**TO:** Design Review Commission  
**FROM:** Eliana Hassan, Assistant Planner  
**SUBJECT:** SC19-0002 – 1229 Woodview Terrace

SC19-0002 – 1229 Woodview Terrace

**Plan Review: SC19-0002**  
**1229 Woodview Terrace**  
**Addition / Remodel**

FRONT ELEVATION

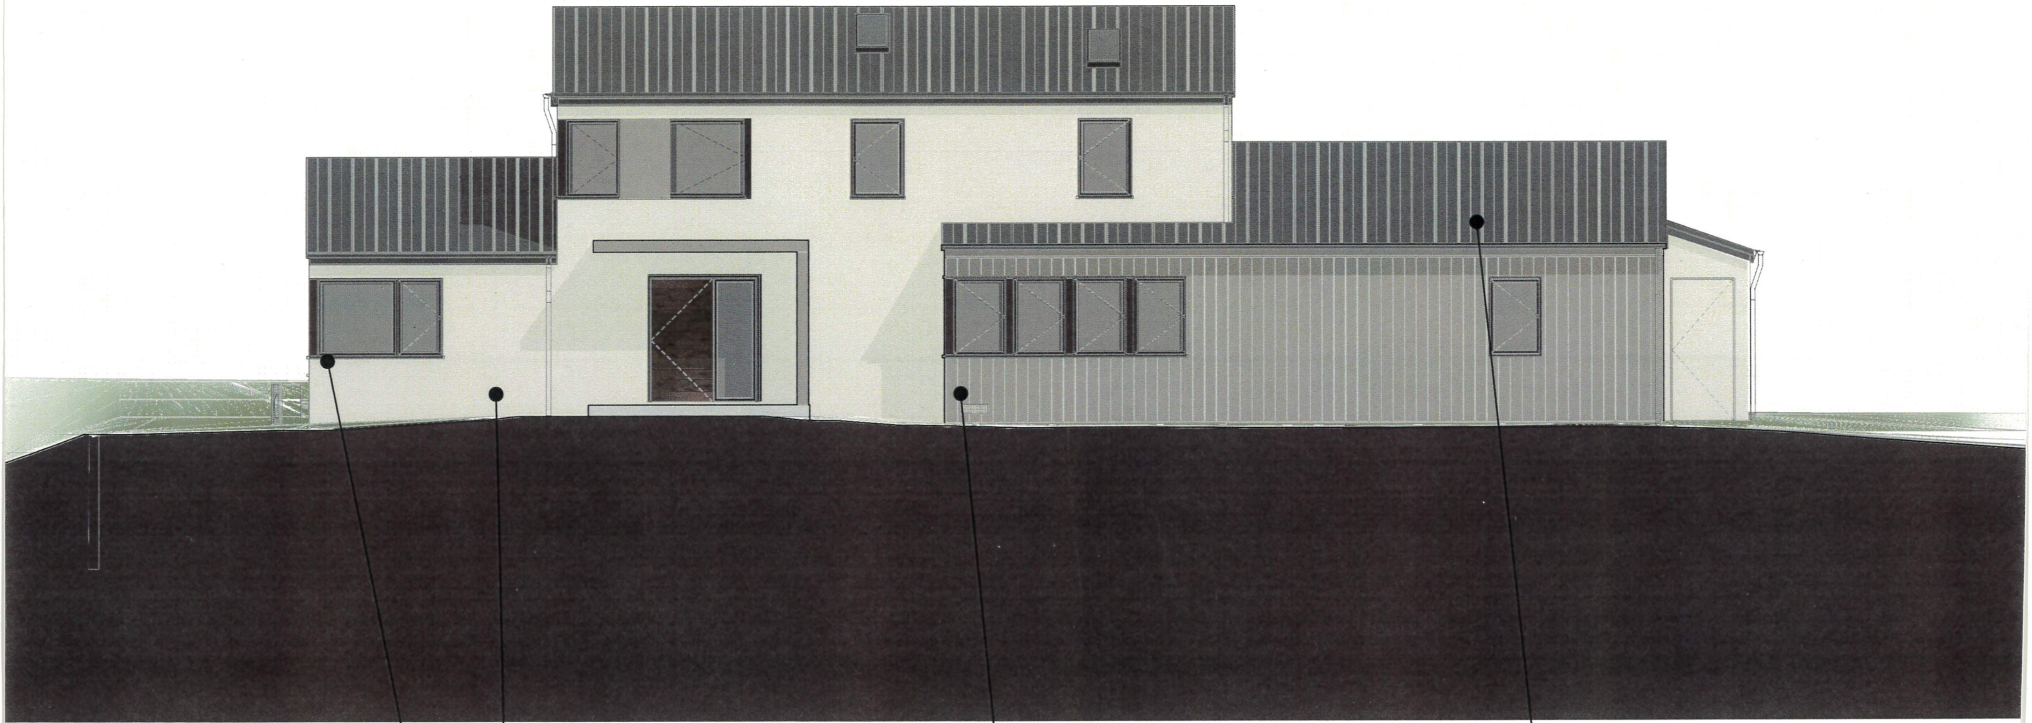
- The materials board has been updated with revised colors and material choices, including a painted wood garage door and a lighter standing seam metal roof color;
- A materials board with physical samples has been included to illustrate colors and textures of proposed materials;
- The bathroom window in the guest bedroom addition was changed to obscure glass;
- The trash enclosure has been redesigned to be more integrated with the exterior side addition;
- A new ornamental tree (Japanese Maple, tree #26) and an evergreen shrub planting area were added to Sheet L1.1 near the guest bedroom addition on the first-floor exterior side; and
- Applicants conducted additional outreach to neighbors as requested by the Commission.

- Update the landscape plan with additional evergreen landscape screening;
- Refine the colors and textures of exterior materials used;
- Do some neighborhood outreach before the next meeting; and
- Provide material board samples.

A cover letter detailing the applicant's neighborhood outreach efforts can be found in Attachment C, and the updated materials board and with enhanced color/texture is included as Attachment D. Overall, with the design revisions and the recommended conditions, the project appears to have addressed the Commission's direction and staff is recommending approval.
